SOUTHERN SEA FARMS LTD  
MAHIMAHI PILOT PLANT  
SANDALWOOD BAY

Report and Recommendations  
of the  
Environmental Protection Authority

Environmental Protection Authority  
Perth, Western Australia

Bulletin 304

Figure 3. Layout of Proposed Pilot Plant  
(from Southern Seas Farms Ltd)

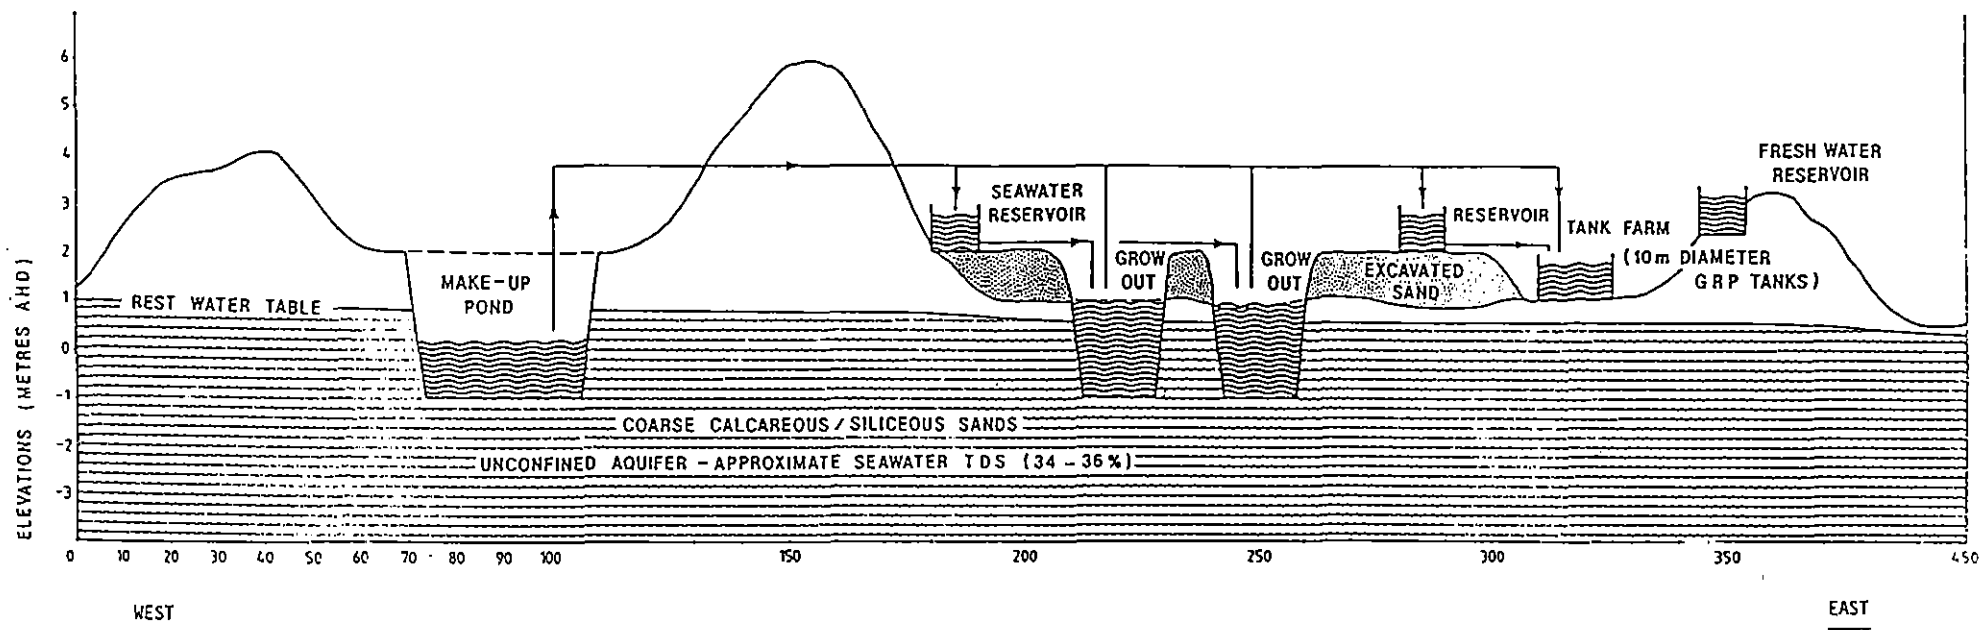
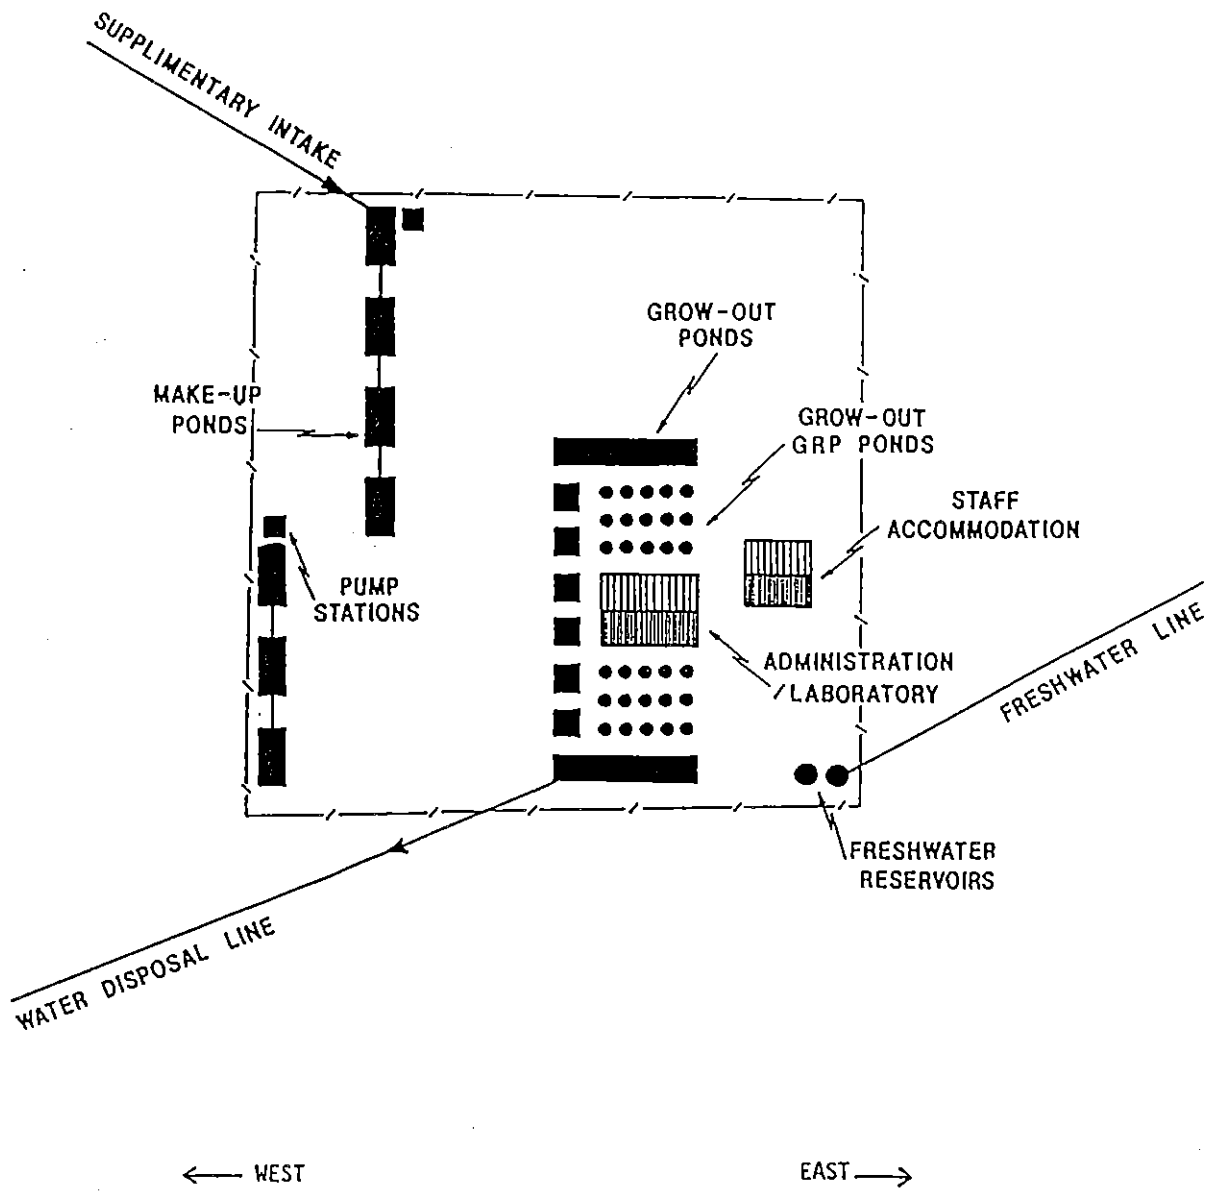
It is proposed to test four types of fish holding facilities: conventional 10 metre diameter fibreglass tanks which would be set on sandpads in the area; shallow unlined ponds, of various shapes and sizes, excavated into the water table in the same manner as the make-up water trench; vinyl lined ponds; and concrete tanks (see Figures 2 and 3).

All overflow water from both the tanks and ponds would be piped back to the coast and discharged into the turbulent surf zone. It is envisaged that the quality of the effluent would be close to that of seawater.
